**Pressure Switch Replacement
 Energy Star II 43VP....E2 Series**

We are starting to see a few field issues with the new ESII Power Vents (43VP...E2); specifically, the error code related to the failure of the pressure switch.

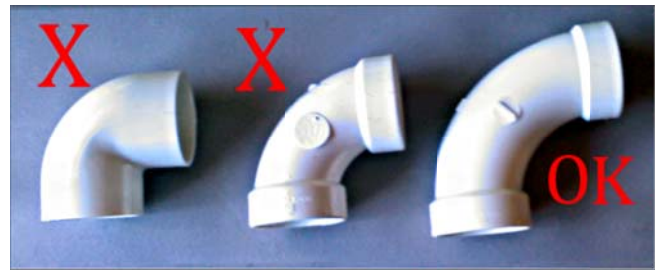
This failure seems to be specific to tall models that have very long runs of 2" venting. While the units may be installed in compliance with the current venting tables found in the Use and Care manual, we are learning that runs of 2" vent may cause the pressure switch to remain closed. We are already working on a solution that will eliminate these nuisance lock outs.

There are a couple of solutions if you experience that situation:

- 1) You can increase the vent size to 3" and the problem will resolve itselfor.....
- 2) You can order a no charge replacement pressure switch through Technical Service. That part number is AP13909.

Replace switch in reverse order with pressure switch -0.85 rating. Reconnect red wires in any order. Reconnect rubber hose.
